**SUBDIVISION,
PLANNED UNIT DEVELOPMENT,
& SIDEWALK WAIVER REQUEST
STAFF REPORT****Date: November 20, 2014**

<u>NAME</u>	McDonald's USA, LLC
<u>SUBDIVISION NAME</u>	Hamilton McDonald's Subdivision
<u>LOCATION</u>	Southeast corner of U.S. Highway 90 West and Hamilton Boulevard
<u>CITY COUNCIL DISTRICT</u>	District 4
<u>PRESENT ZONING</u>	B-3, Community Business District
<u>AREA OF PROPERTY</u>	2 Lot / 6.9± Acres
<u>CONTEMPLATED USE</u>	<i>Planned Unit Development</i> approval to shared access and parking between two building sites, <i>Subdivision</i> approval to create 2 legal lots of record, and <i>Sidewalk Waiver</i> approval to waive construction of sidewalks along U.S. Highway 90 West and Hamilton Boulevard.
<u>TIME SCHEDULE FOR DEVELOPMENT</u>	2015

APPLICATION NUMBER 2 DATE January 15, 2015
APPLICANT Hamilton McDonald's Subdivision
REQUEST Subdivision, Planned Unit Development, Sidewalk Waiver

SITE PLAN

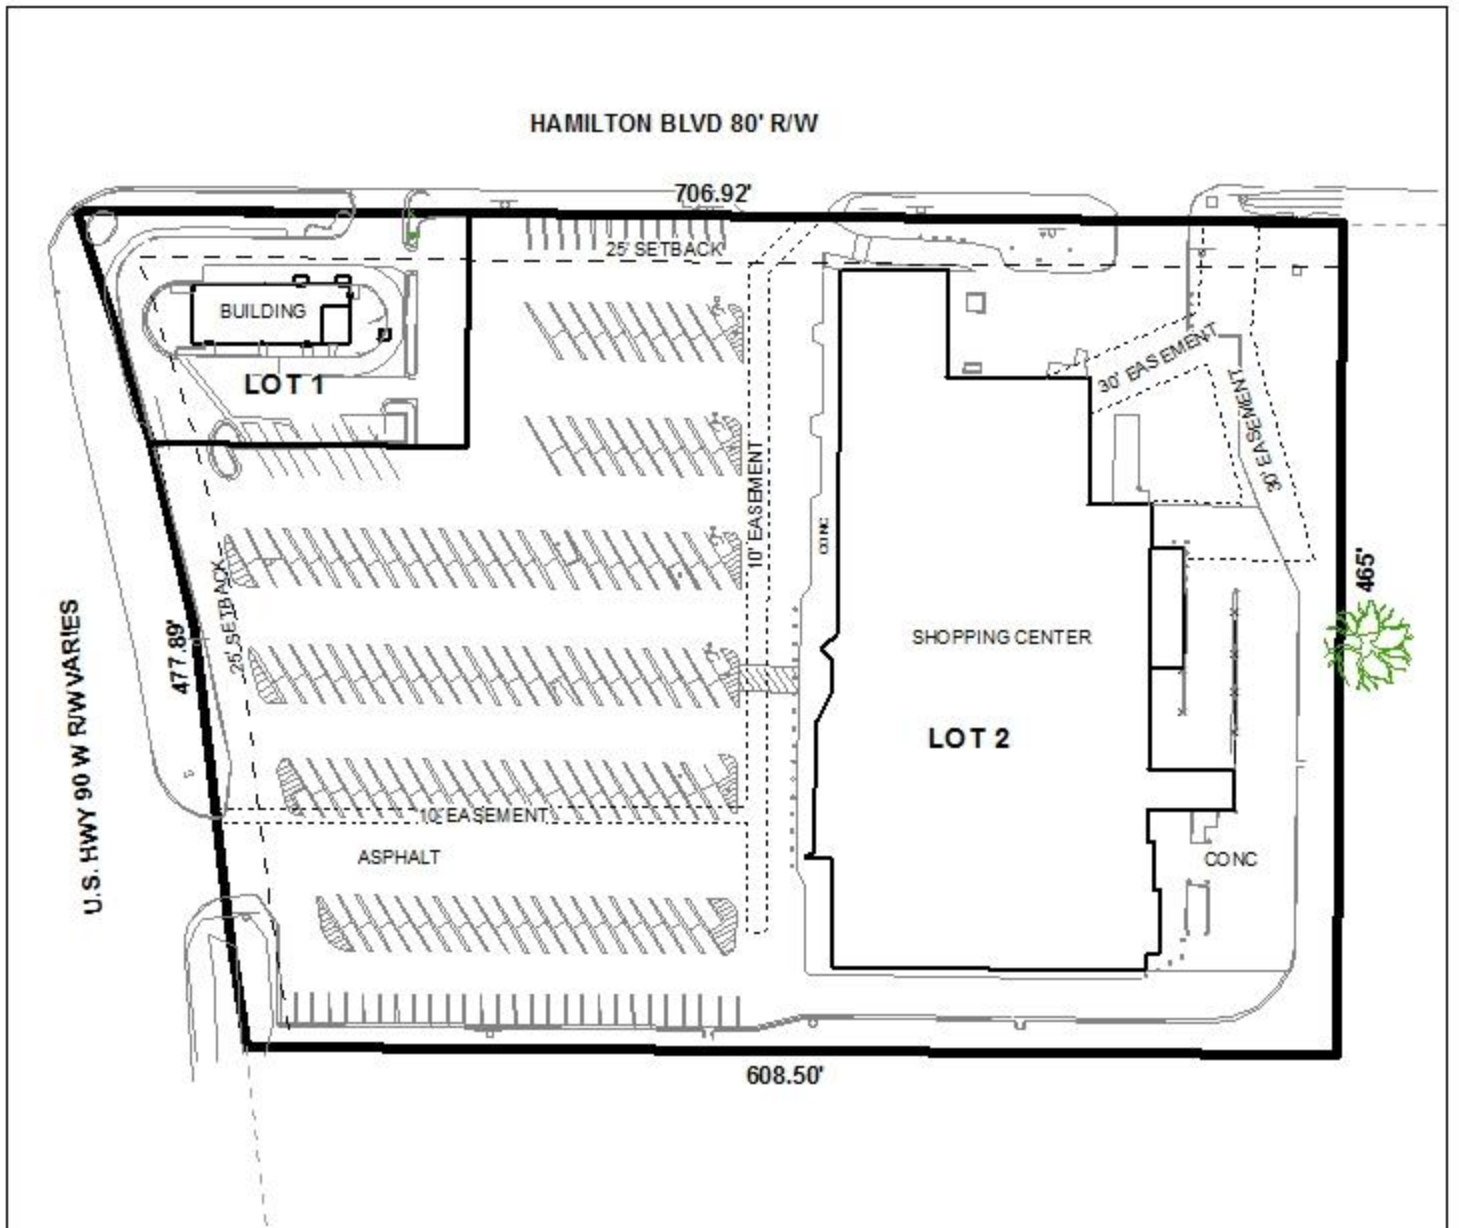
The site fronts Hamilton Boulevard and U.S. Highway 90 West, both planned major streets. The Major Street Plan component of the Comprehensive Plan calls for 100-feet of right-of-way for Hamilton Boulevard, and a 250-foot right-of-way for U.S. Highway 90 West. Hamilton Boulevard is illustrated as having an existing right-of-way of 80-feet, while U.S. Highway 90 West is illustrated as having an existing right-of-way that varies. While dedication would typically be required, this would result in existing parking spaces and maneuvering areas being located within the right-of-way. If approved, an increased setback should be illustrated to accommodate the future right-of-way. The minimum right-of-way width of U.S. Highway 90 West should be labeled. The minimum building setback line should be adjusted an additional 10 feet.

There is a 10' sanitary sewer easement and a 30' Alabama Power utility easement on the site. A note should be placed on the Final Plat stating that no structures shall be erected in any easement.

- 1) retention of the lot sizes in square feet and acres;
- 2) revision of the minimum building setback line to accommodate the future right-of-way along both U.S. Highway 90 West (125' from centerline) and Hamilton Boulevard (50' from centerline);

- 4) placement of a note stating that no structures will be erected in any easement;
- 5) placement of a note on the site plan stating that both lots are limited to existing curb cuts, with the size, design and location to be approved by ALDOT (where applicable) and Traffic Engineering and comply with AASHTO standards;

SITE PLAN

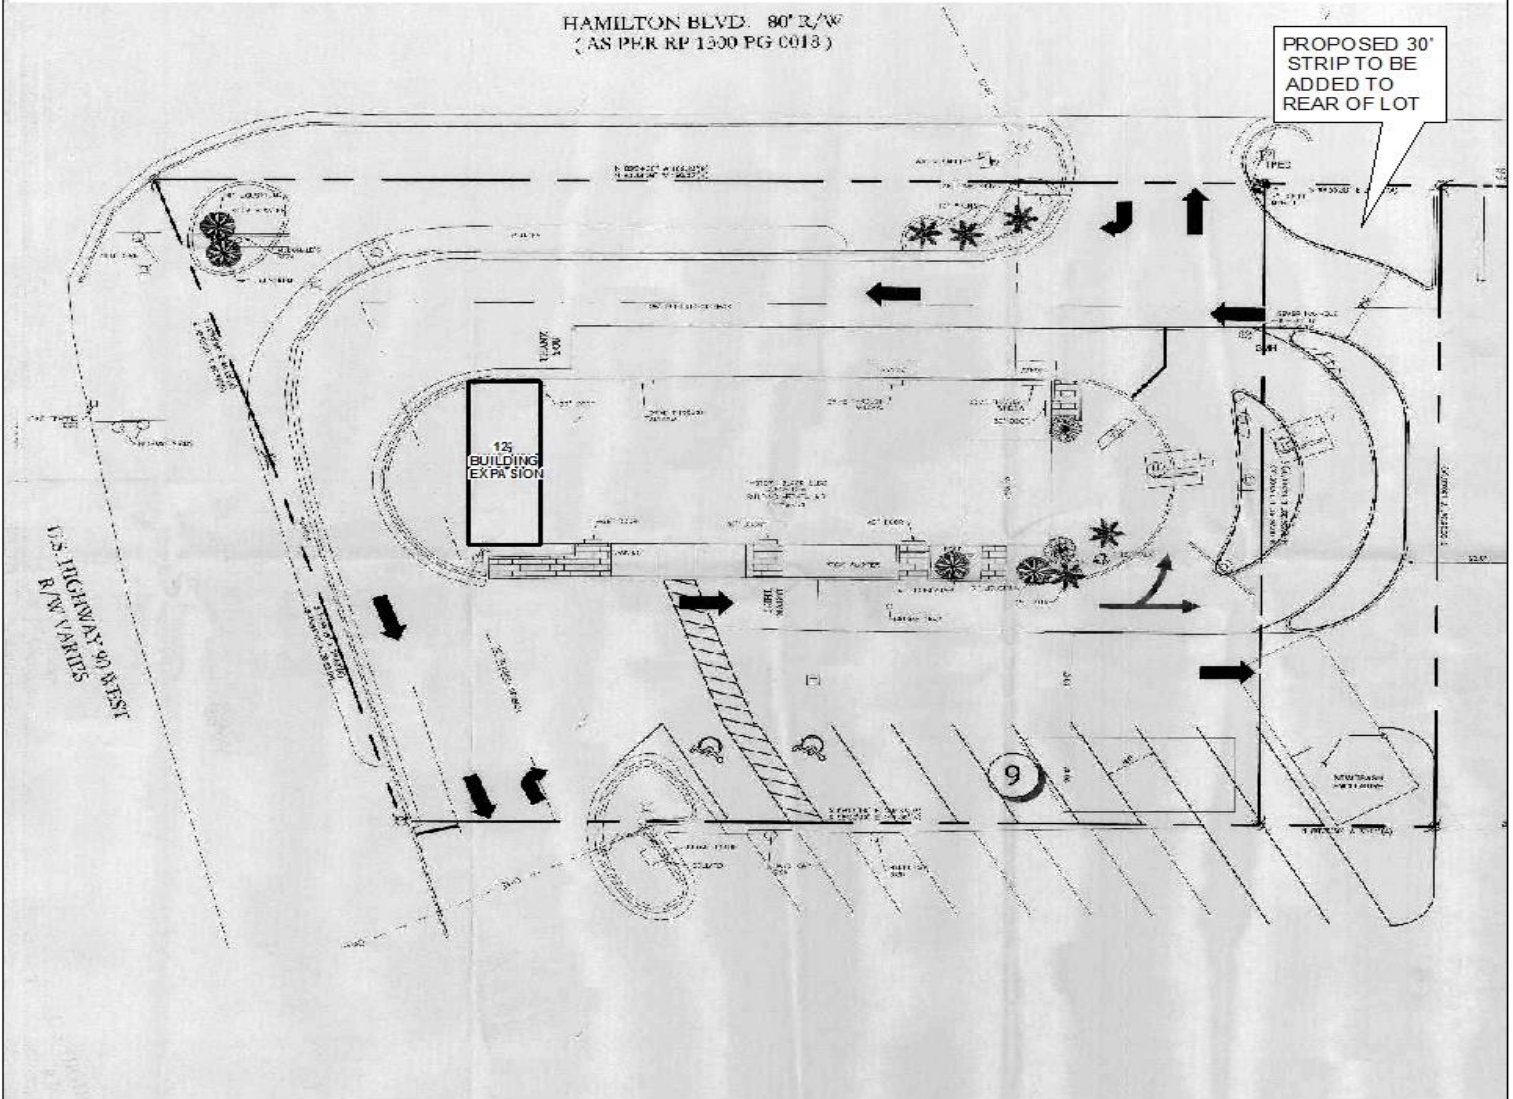
The applicant is proposing to re-locate an interior property line to accommodate a second drive-thru lane for an existing fast-food restaurant that currently shares access and parking with an existing shopping center.

The total amount of square footage for retail and restaurant usage is not provided; therefore it is difficult for staff to determine if the site provides the minimum number of parking spaces
